# **DEVELOPMENT APPLICATION ASSESSMENT REPORT**

DA2025/0380

DA2025/0380		
Julie Edwards		
Lot 2A DP 444638, 51 Boyle Street BALGOWLAH NSW 2093		
Alterations and additions to a semi-detached dwelling		
Manly LEP2013 - Land zoned R1 General Residential		
Yes		
No		
Northern Beaches Council		
No		
Cape Cod Australia Pty Ltd		
11/04/2025		
No		
No		
Residential - Alterations and additions		
22/04/2025 to 06/05/2025

Image 1: Building Height non-compliance high lighted in red.

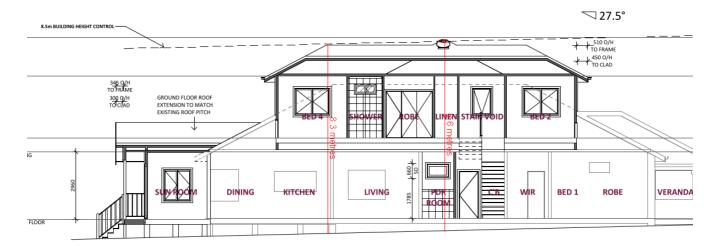
Development standard:	Height of buildings
Requirement:	8.5m
Proposed:	8.6m
Percentage variation to requirement:	1.17%

Percentage of variation: 1.17%

Council is satisfied that the Applicant has demonstrated that compliance with Clause 4.3 Height of Buildings is unreasonable or unnecessary in the circumstances of this application for the following reasons:

Council is satisfied that the Applicant's written request under Clause 4.6 of the Manly Local Environmental Plan 2013 seeking to justify variation of the development standard contained within Clause 4.3 Height of Buildings has adequately addressed and demonstrated that:
